**DRAINAGE REPORT
FOR
THE CROSSRIVER AND RANCHO SILVERADO**

**PINNACLE PEAK DIVERSION CHANNEL
FOR
OFFSITE FLOWS
LOCATED ALONG THE PINNACLE PEAK
ROAD EXTENDED ALIGNMENT
BETWEEN
123RD AVENUE AND McMICKEN OUTFALL WASH**

June 1, 2004
Revised July 16, 2004, February 18, 2005 & July 26, 2005

We submitted plans to FCDMC on February 23, 2005, and received your review comments via e-mail on April 1, 2005. Those requested analyses, additions and changes to the plans and drainage report have been completed. Seven sets of revised plans and drainage reports together with 2-copies of the revised legal description are submitted herewith for your review and approval.

SHEET
1 OF 3

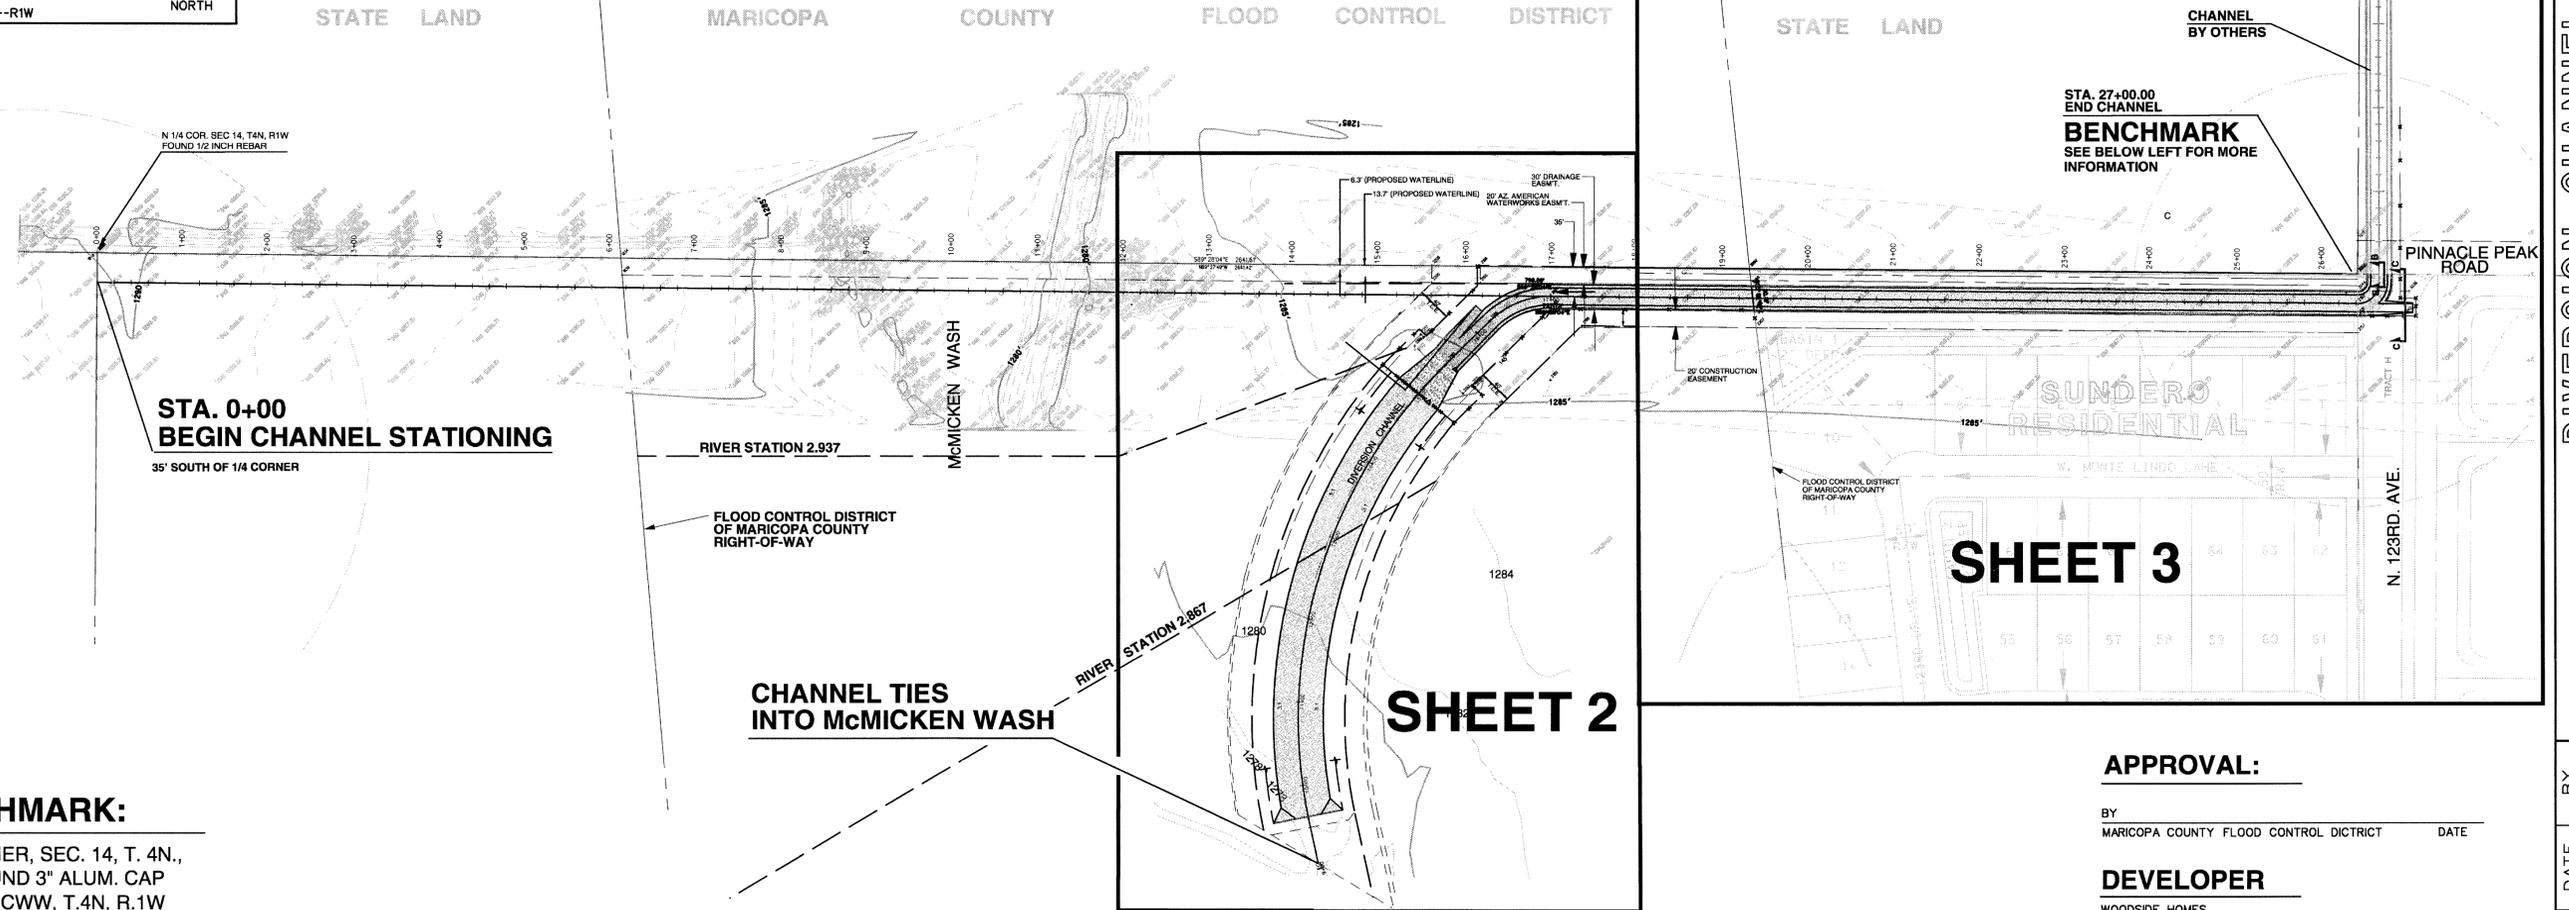
- 13. The floodway depicted on the plans appears to be quite different than the one in the FCD GIS database. The floodway on the plans has a northwest to southeast trending orientation. The FCD floodway is pretty much north to south in its orientation. Please check to see that you have the correct floodway and floodplain because this will affect where the channel is terminated.*

This has been checked and we believe it to be correct.

PROFESSIONAL ENGINEER
 7551 CHARLES DEE SCOTT
 10/28/02
CHANNEL PLANS
 SHEET 2 OF 3
 990050

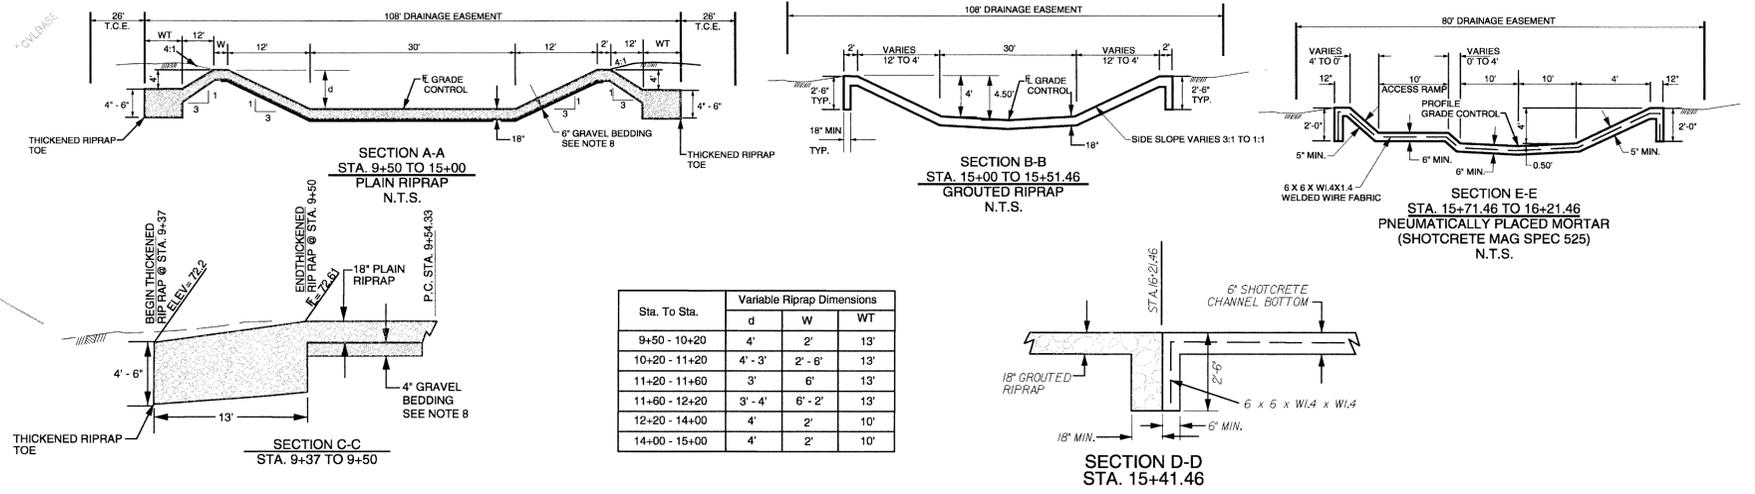
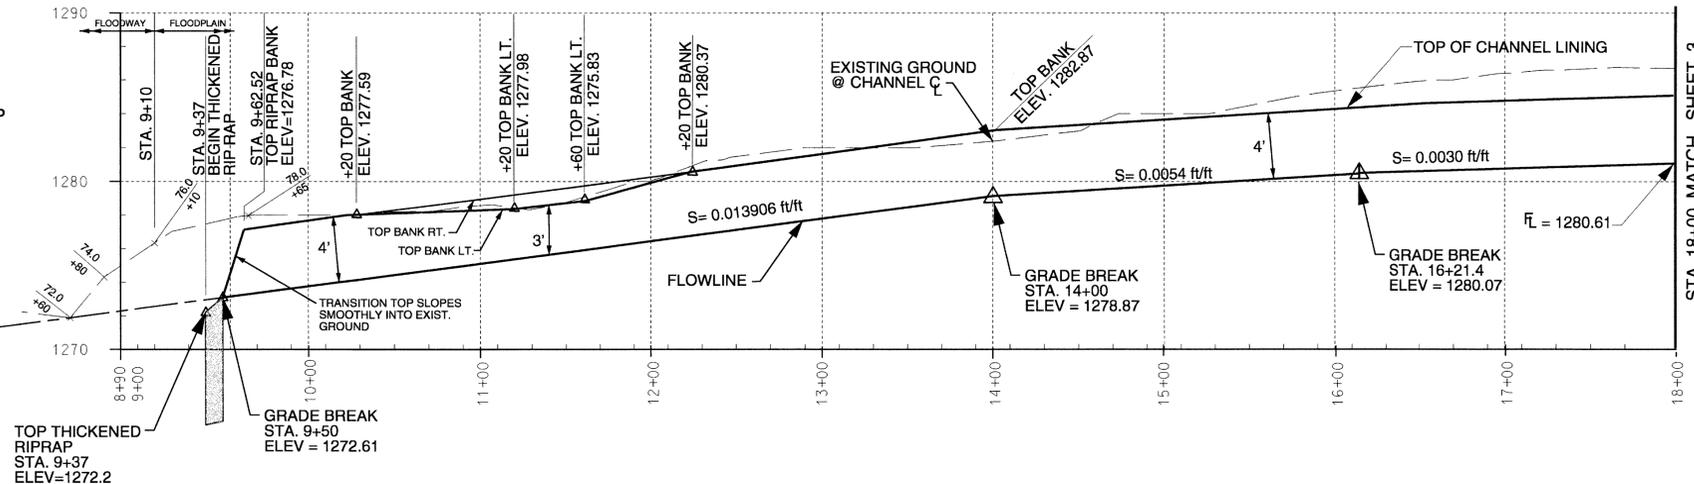
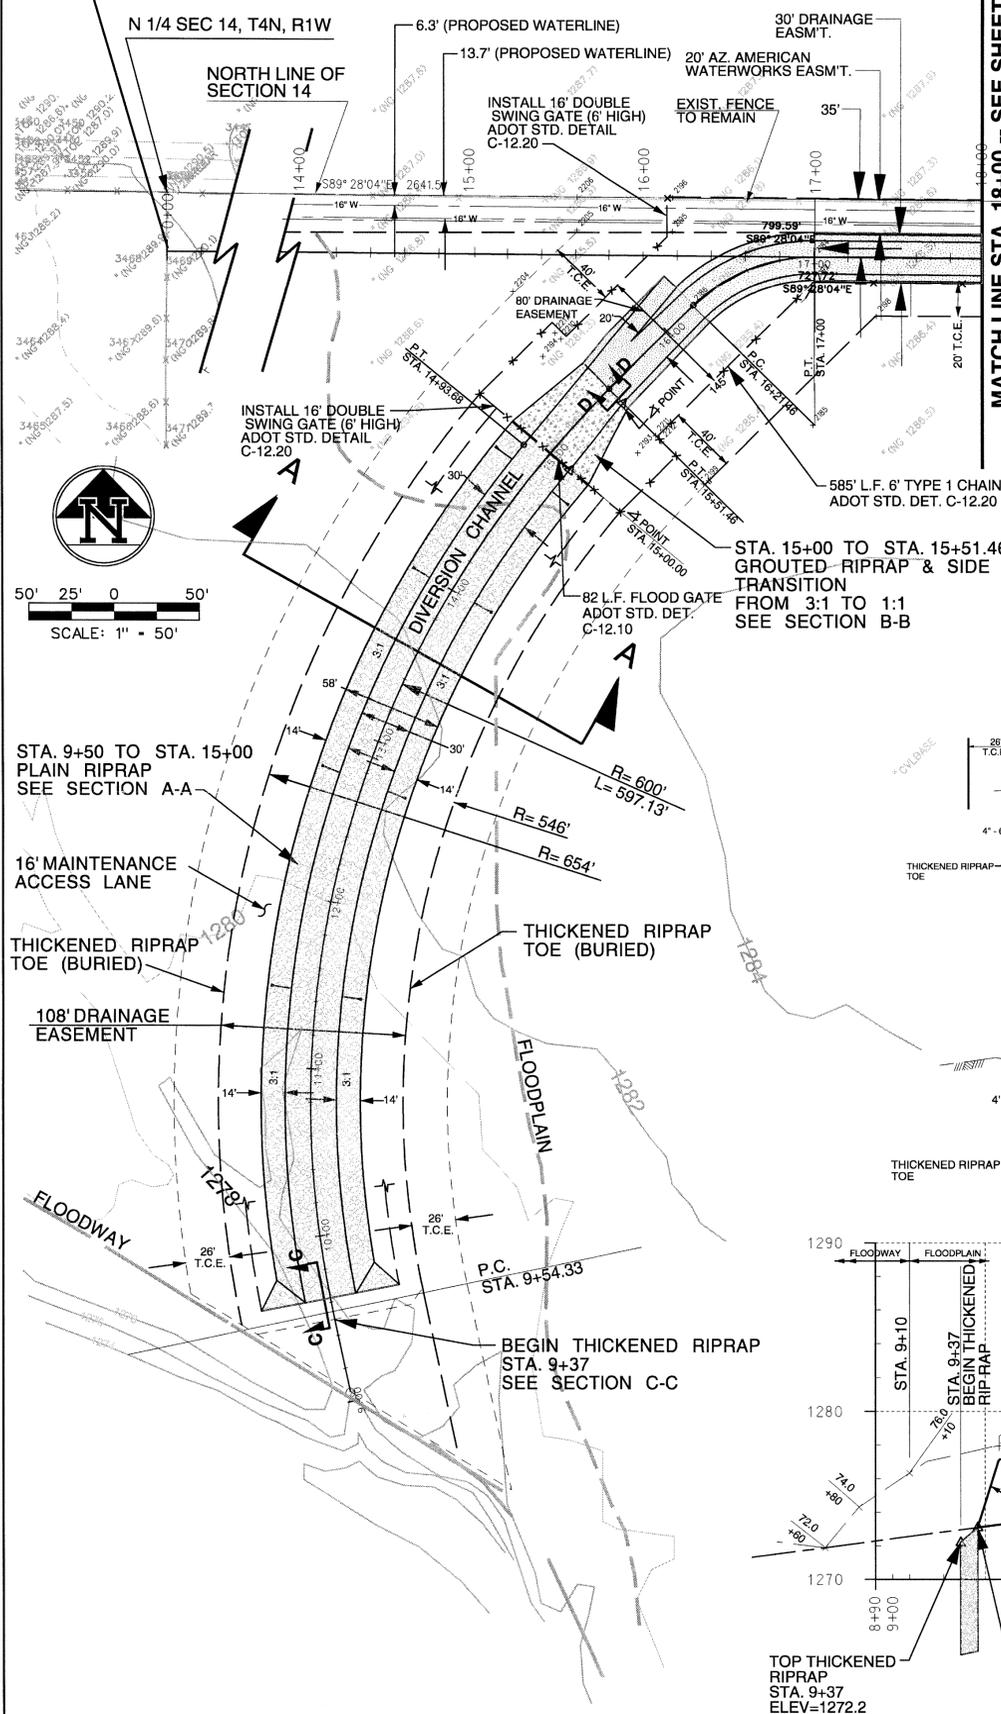
2. *The scour analysis provides a recommended toe down of 9.3 feet. I am assuming this is the basis for the design of the cutoff shown in Section C-C on Sheet 2 of 3. If my assumption is correct, how were the cutoff depths shown on the table for Section A-A on the same sheet determined?*

3. *The design now includes riprap breaks shown on the plan view and Section E-E on Sheet 2 of 3. Why were these included and how were the depths shown in the adjacent table determined?*

7. *In general the report needs to explain the design process much better. How do the calculations for scour relate to the plans presented for review? For example, a value of 9.3 feet was calculated for scour/toe down. Section c-c on sheet 2 of the plans has a toe down of 10.5 feet. Are these related, please explain?*

8. *Sheet 2 of the plans has a table of variable riprap dimension. How were these values acquired and why are they so different?*

9. *Sheet 2 has riprap breaks on the east side of the diversion channel. Please explain the purpose of the breaks.*

The outside of the riprapped channel will be protected using thickened toe bank protection as described in the Drainage Design Manual for Maricopa County, Volume II, pages 6-51 thru 6-53. Sufficient volume was added to the thickened toe as well as protection at the downstream end of the channel to protect against erosion under the channel by McMicken Wash flows.

Additional narrative has been added to the report explaining the process.
